CAMERON COUNTY REGIONAL MOBILITY AUTHORITY
CAMERON COUNTY BENAVIDES PARK PAVILION
PROJECT # 2021-C2003421

ADDENDUM NO. 1

This addendum is issued for the purpose of modifying the plans and specifications for the Cameron County Benavides Park Pavilion.

E1.01

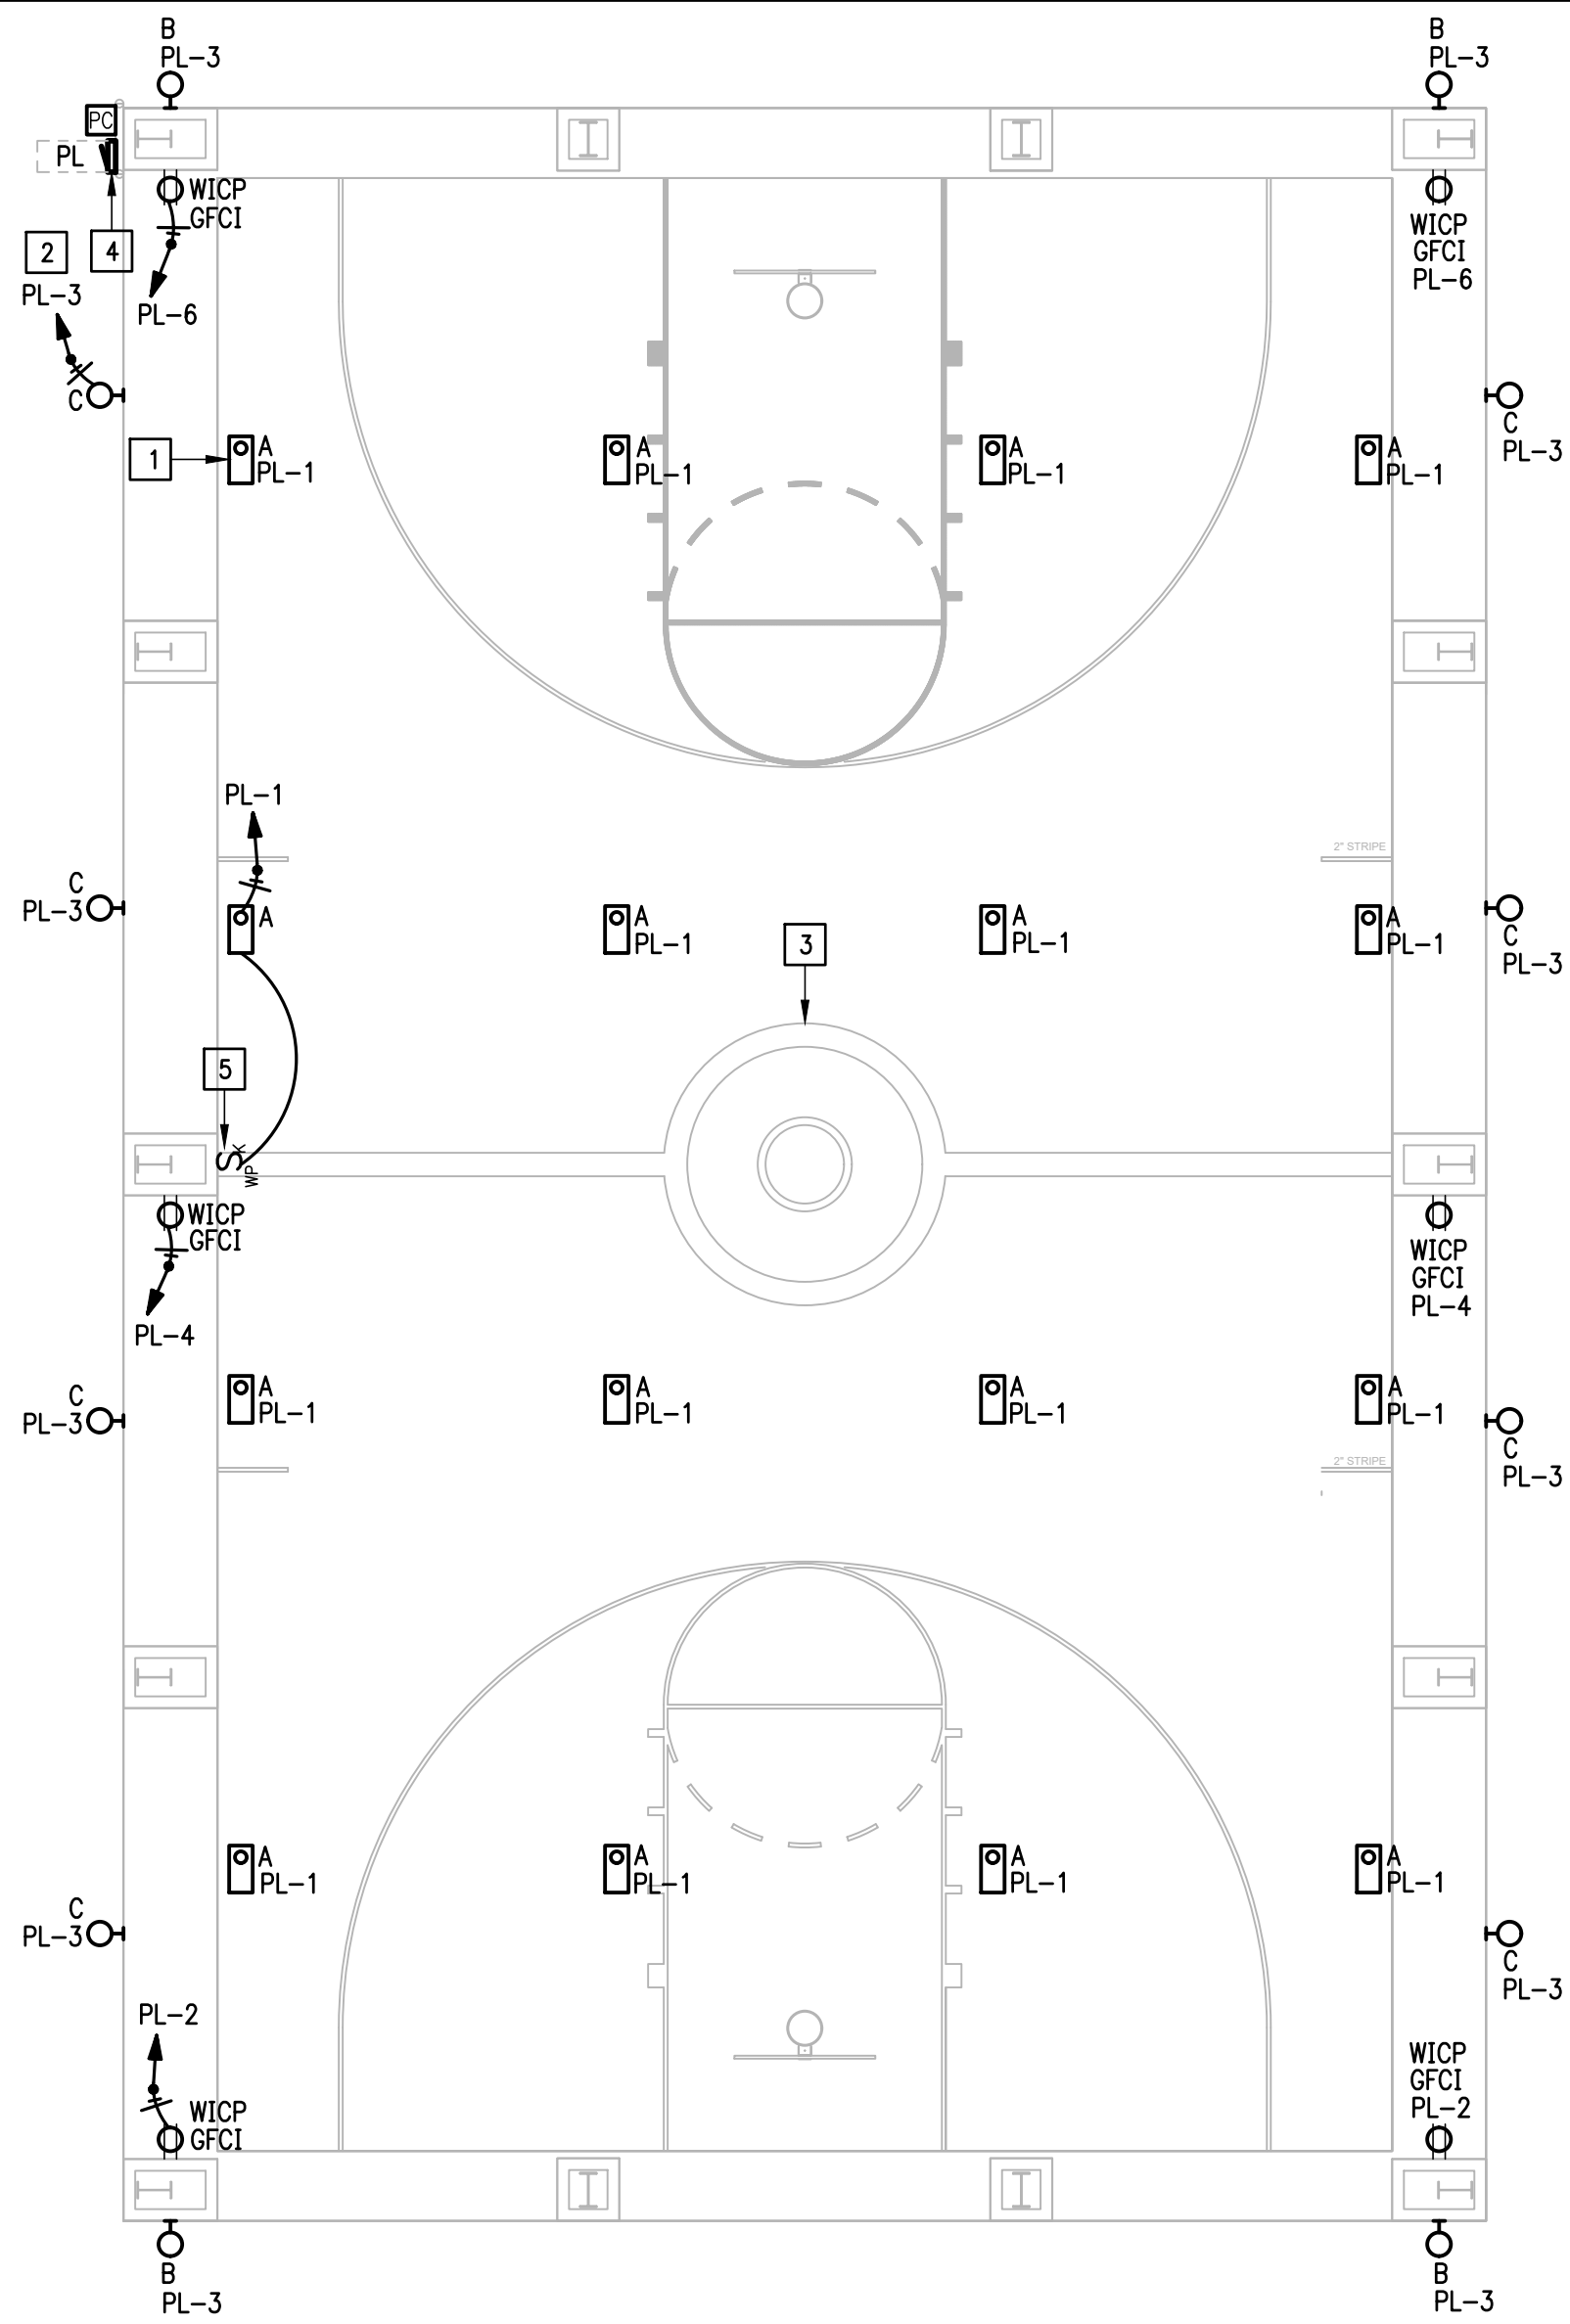
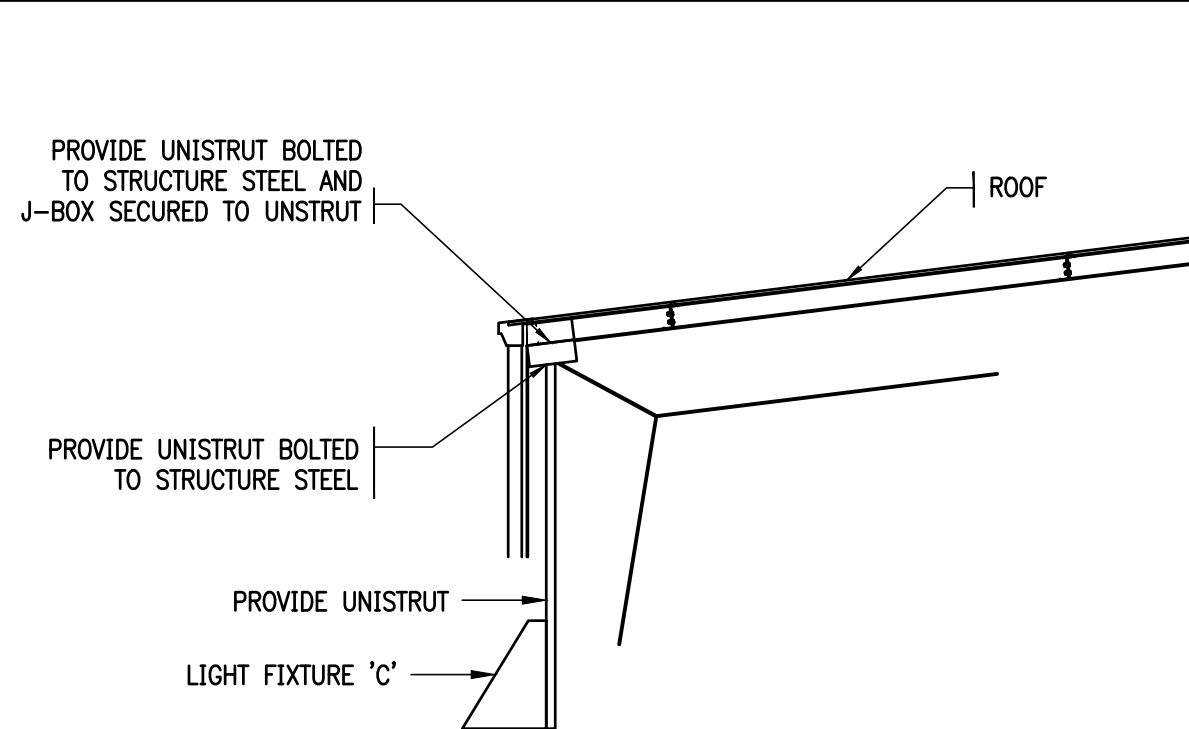
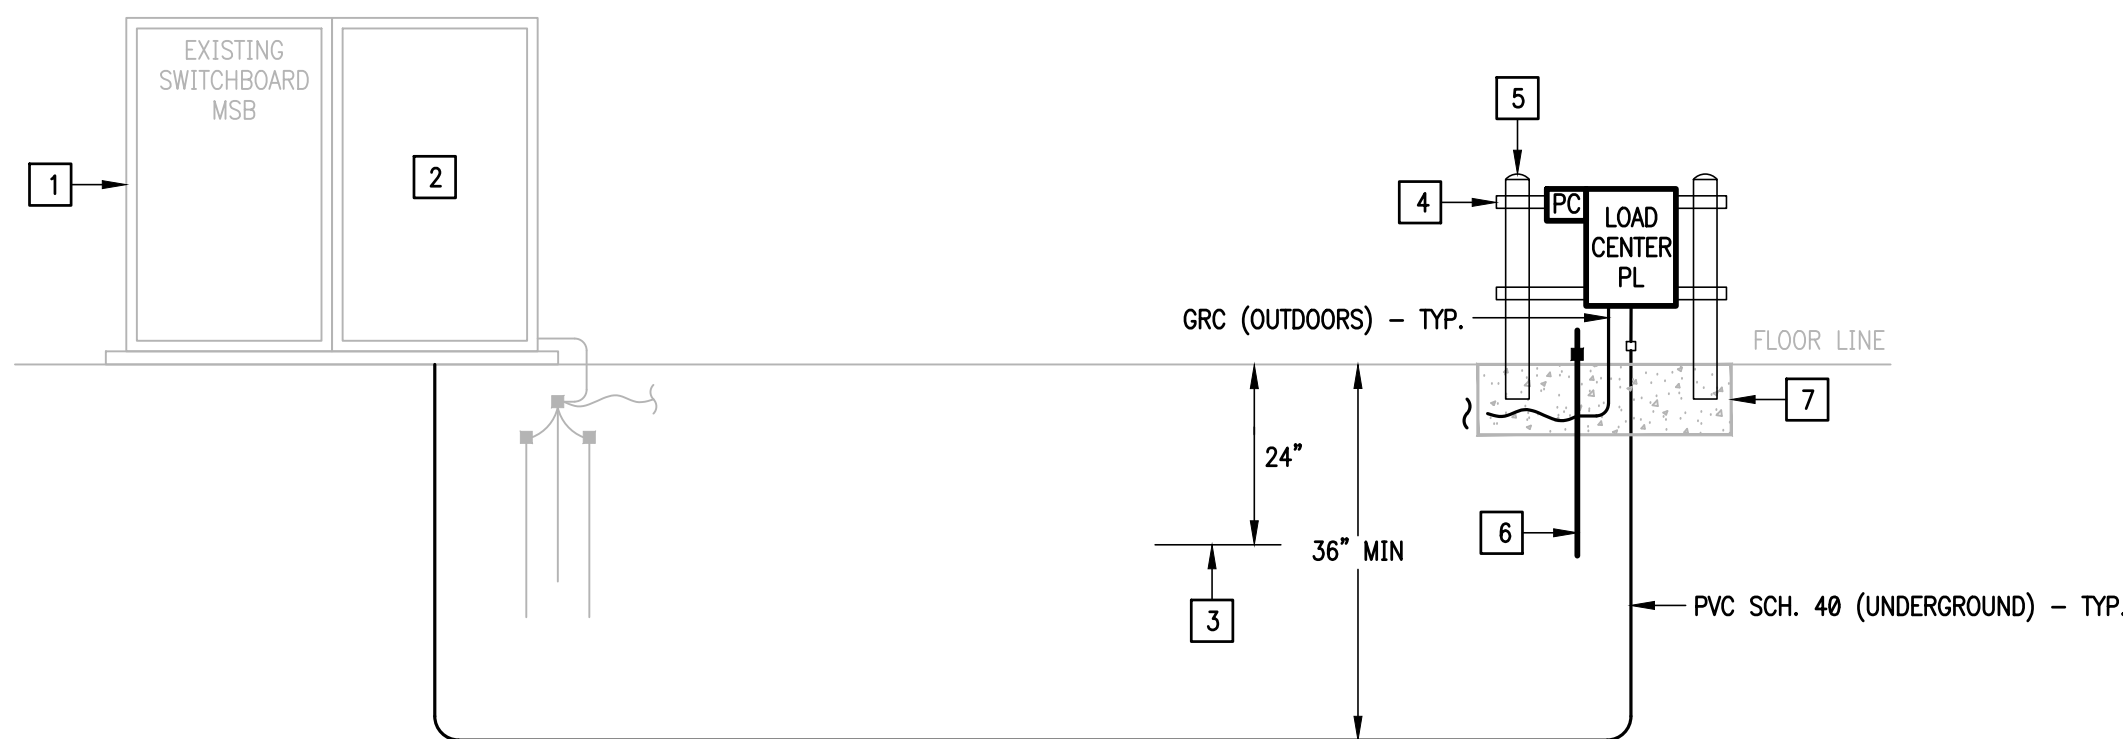
- Delete Sheet E1.01 and E1.02 from construction documents and in lieu of use the attached E1.01 and E1.02.

- 1 MOUNT FIXTURE TYPE "A" TO BOTTOM OF STRUCTURE STEEL WITH UNISTRUT – TYPICAL.
- 2 SWITCH VIA PHOTOCCELL.
- 3 ALL RACEWAYS, BOXES & SUPPORTS WITHIN THE PAVILLION SHALL BE RIGID METALLIC GALVANIZED STEEL (RMC).
- 4 PROVIDE UNISTRUT SUPPORT.
- 5 PROVIDE WEATHER PROOF STEEL LOCKING COVER FOR SWITCH.

- 1 EXISTING CUTLER HAMMER SWITCHBOARD 1200A, 277/480V, 3Φ, 4W.
- 2 CONNECT ELECTRICAL PACKAGE POWER SUPPLY "PL" TO EXISTING SWITCHBOARD. PROVIDE NEW 30A/2P CIRCUIT BREAKER IN AVAILABLE SPACE.
- 3 PROVIDE CONTINUOUS DETECTABLE UNDERGROUND WARNING TAPE.
- 4 PROVIDE 3-1/4" X 1/2" X 5/8", 12 GAUGE UNISTRUT, HOT DIP GALV. AFTER FABRICATION.
- 5 PROVIDE 4" DIA. X 6' (ABOVE GROUND) HOT DIP GALV. STEEL PIPE WITH CAP.
- 6 PROVIDE 3/4" X 10' COPPER CLAD GROUND ROD AND 3/4" - #8 BARE COPPER CLAD ELECTRICAL CONDUCTOR. PROVIDE CADWELD CONNECTION TO FOUNDATION REBAR AND STRUCTURAL STEEL.
- 7 24" WIDE X 24" LONG X 2" DEEP (AFTER ABOVE GRADE) CONCRETE FOOTING WITH #4 REBAR WELDED ON TO 4" DIA. STEEL PIPE.
